Preliminary Information

PIT5251C EZ Lower Tailgate Opens Too Quickly / Additional Effort To Close

with EZ Lift and Lower Tailgate (RPO PPA)

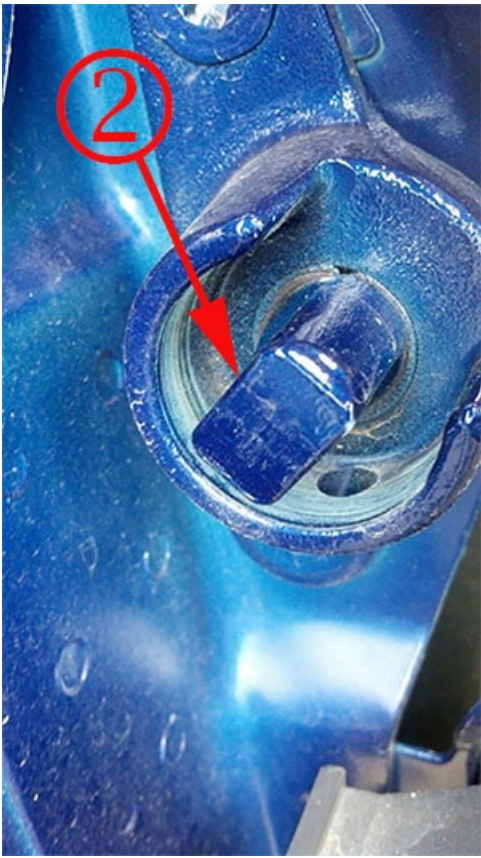
3. If the tailgate opens too quickly, inspect the right tailgate bushing. The right tailgate bushing (1) has a double flat design which keys/splines the tailgate to the dampener shaft (2). If the right tailgate bushing (1) becomes deformed/cracked/broken/etc., the dampener will no longer be keyed/spined to the tailgate. This can cause the tailgate to open too quickly. The tailgate bushing would need to be replaced to correct this concern.
